Comhairle Chontae Atha Cliath Theas

Record of Executive Business and Chief Executive's Order

Reg. Reference: SD22A/0099 **Application Date:** 06-Apr-2022

Submission Type: Clarification of Additional Information **Registration Date:** 24-Nov-2022

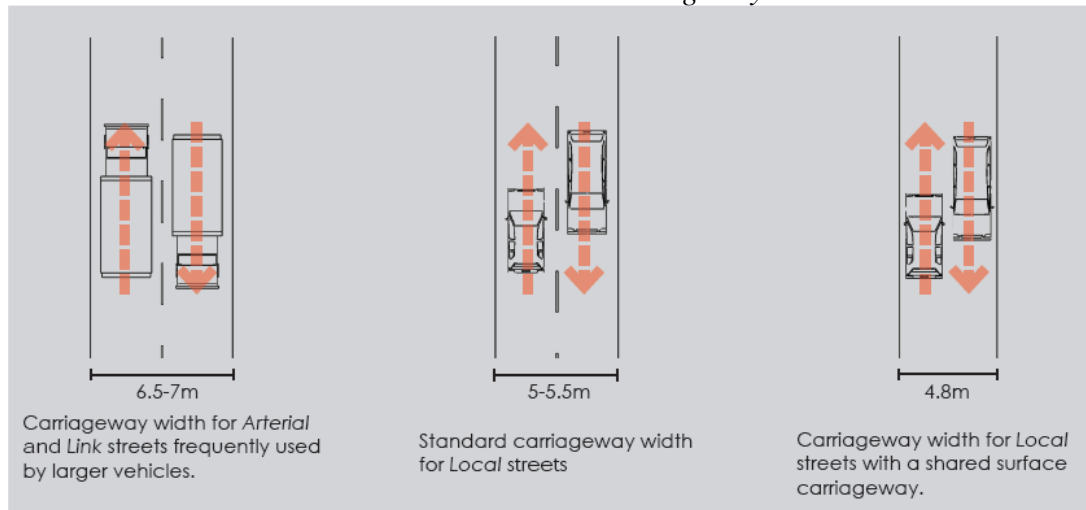
d) Detailed Design

Section 4 of DMURS, recommends that designers should minimise the width of carriageways to help achieve self-relating streets (in terms of speed and road safety), to create streetscapes and to help create pedestrian and cyclist environments.

Illustration of Corner Radii/Street Entrance Designs for Larger Vehicles and Pedestrians

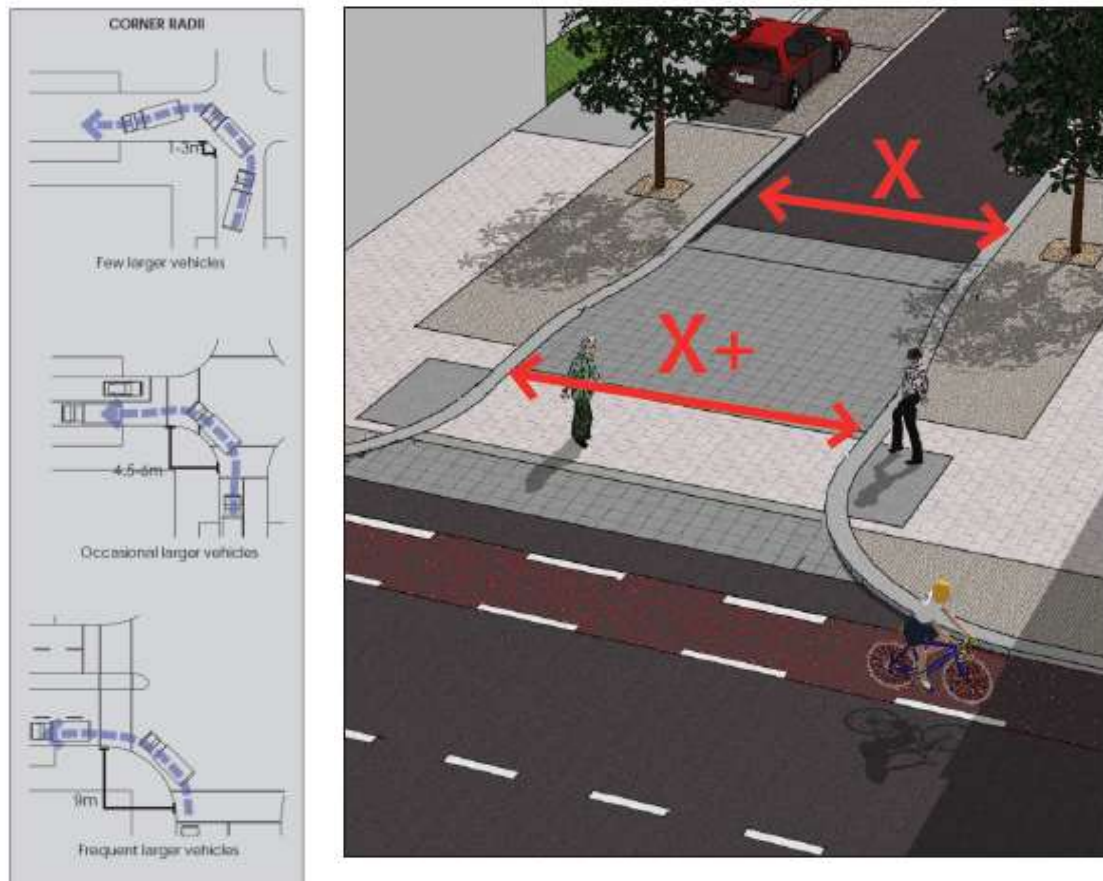
Further to the applicant's indication of the need to accommodate swept path manoeuvring requirements for larger vehicles, tight corner radii (approx. 3 metres) are proposed at junctions with the loading areas, parking areas and internal streets, which is equivalent to that recommended by DMURS where movement by larger vehicles is infrequent. As a result, the applicant is proposing a north-south road that would have a width that far exceeds that recommended for the highest order street and has incorporated junctions/corner radii that would be applicable to the lowest order street typology (Local Street).

As per the diagrams above, DMURS (2019) indicates that corner radii of between 4.5 and 9 metres may be used to accommodate occasional or frequent larger vehicles to turn corners. It is also illustrated how tighter corner radii can be applied to a junction while retaining pedestrian and cyclist safety, with additional manoeuvrability for larger vehicles provided by widening the street entrance (see diagrams below).
